**TOWN OF NEWBURGH  
PLANNING BOARD  
TECHNICAL REVIEW COMMENTS**

**PROJECT NAME:** DARRIGO SOLAR  
**PROJECT NO.:** 19-24  
**PROJECT LOCATION:** SECTION 86, BLOCK 1, LOT 96  
**REVIEW DATE:** 26 JANUARY 2024  
**MEETING DATE:** 1 FEBRUARY 2024  
**PROJECT REPRESENTATIVE:** ARDEN CONSULTING

Subject: Darrigo Solar Farm Landscape Plan Comment Response Memo  
Comments Received by Email (Town Project Number 2019-14)

# AMENDED 5 MW AC SOLAR FARM SITE PLAN FOR DARRIGO 84 LAKESIDE AVENUE TOWN OF NEWBURGH – ORANGE COUNTY, N.Y.

**2 DECORATIVE METAL FENCE PANEL**  
SCALE: NTS  
CROSS REFERENCE: NONE

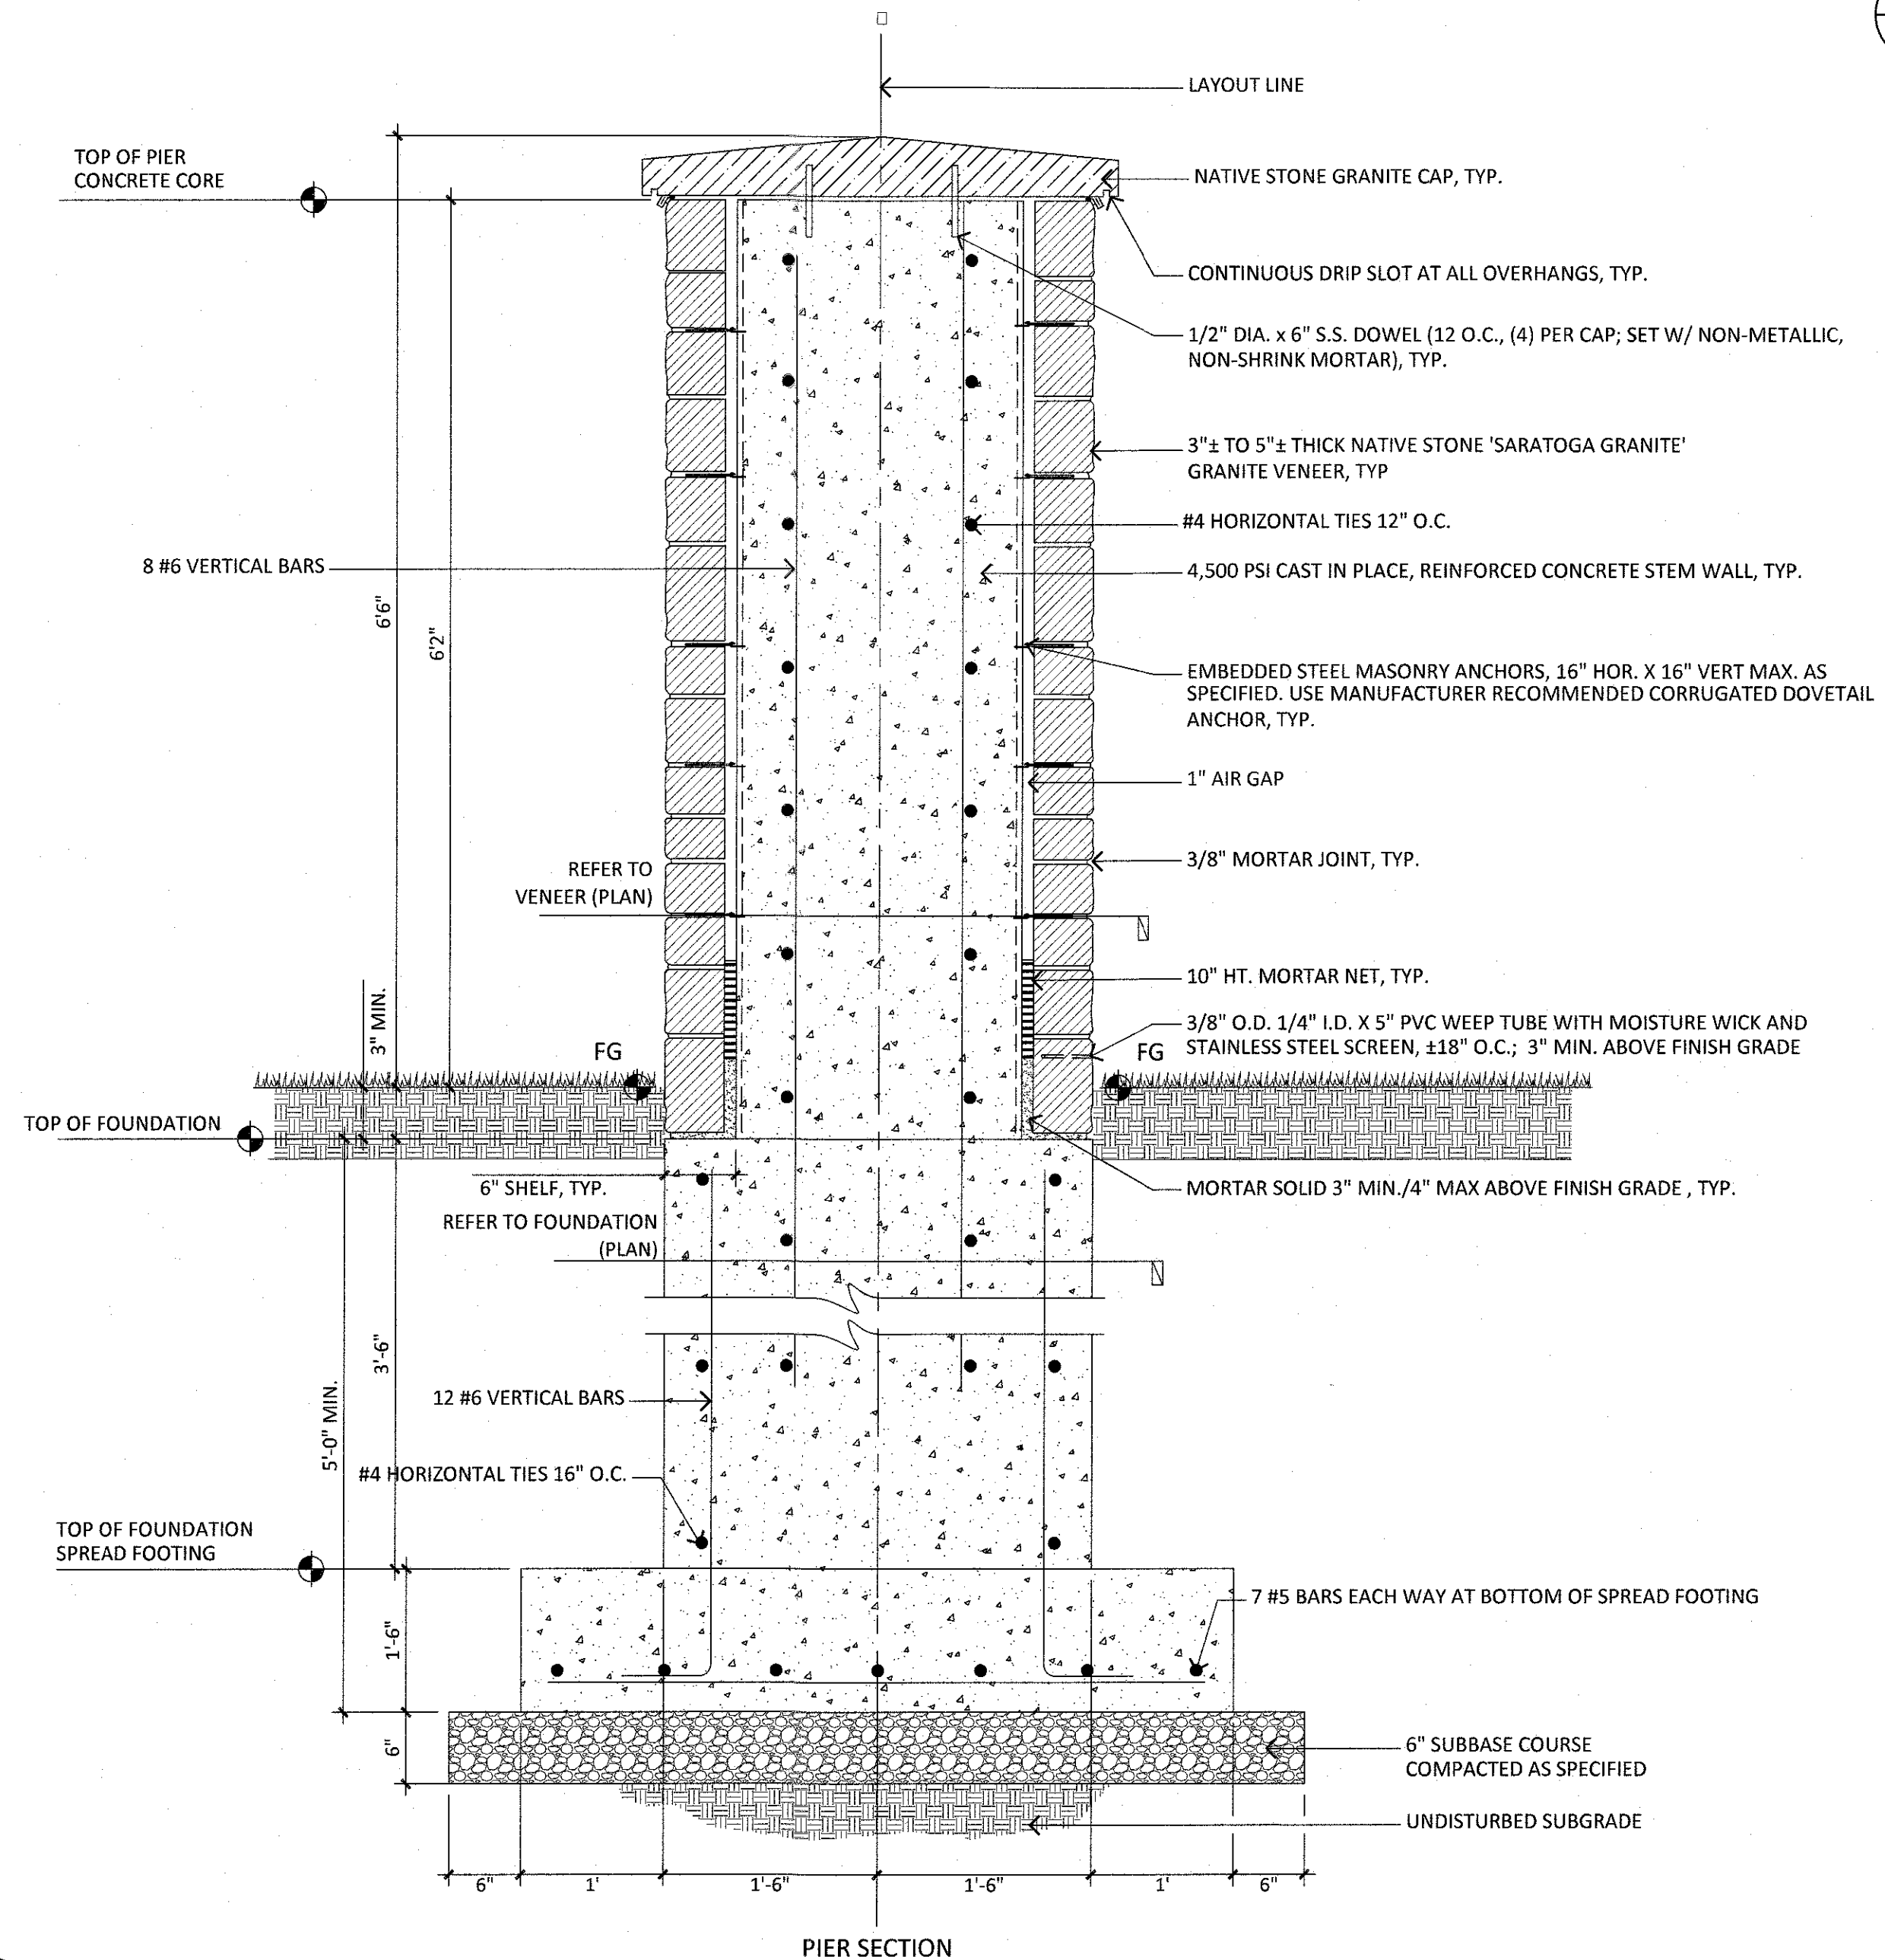
5. No fence details were included. Please include a detail for the proposed fencing at the lakeside road entrance. Fence and gate details have been added on Sheet L-502.

5. Please include a detail for the proposed fencing at the Lakeside road entrance. This fence will be highly visible from the road and it should be aesthetically pleasing.

5. No fence details were included. Please include a detail for the proposed fencing at the lakeside road entrance.
6. Please forward the enlarged planting plan so we can make sure this comment was addressed.
